Access Compliance Report Public Rights-of-Way (Curb Ramps)

Main Street: RUTH_ELAINE_DR		Cross Street: DONNIS_RD		Location:	NW
ADA ID: RPAT220225110919	Ramp Type:Type 1 - Perpendicular	Initial Pass/Fail: Fail	Overall Compliance: No	Severity Score:	15

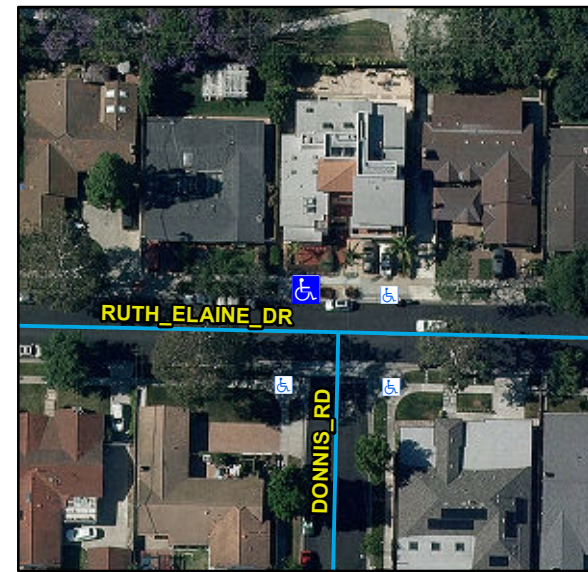
Compliance	Description	Data	Compliance	Description	Data
N/A	Ramp Length (in)	85	N/A	Flare Type LT	
Yes	Ramp Width (in)	54			N/A
No	Ramp Run Slope (%)	9	N/A	Flare Slope LT (%)	N/A
Yes	Ramp Cross Slope (%)	0.3	N/A	Flare Traversable LT	N/A
N/A	Landing Present	N/A	N/A	Flare Type RT	
N/A	Landing Length (in)	N/A			N/A
N/A	Landing Width (in)	N/A	N/A	Flare Slope RT (%)	N/A
N/A	Landing Run Slope (%)	N/A	N/A	Flare Traversable RT	N/A
N/A	Landing Cross Slope (%)	N/A	N/A	DWS Provided	N/A
N/A	Landing Movement Obstructed?	N/A	N/A	DWS Contrast	N/A
	Landing Movement Type	N/A	N/A	DWS Length (in)	N/A
N/A	Landing Shared	N/A	N/A	DWS Full Width	N/A
N/A	Clear Space	N/A	N/A	DWS Offset Left (in)	N/A
N/A	Clear Space To Crosswalk (in)	N/A	N/A	DWS Offset Right (in)	N/A
N/A	Marked Crosswalk 1	No	N/A	Marked Crosswalk 2	N/A
	Crossing 1 Direction	S		Crossing 2 Direction	N/A
	Marked Crosswalk 1 Width (in)	N/A		Marked Crosswalk 2 Width (in)	N/A

Remove & Replace Entire Ramp.
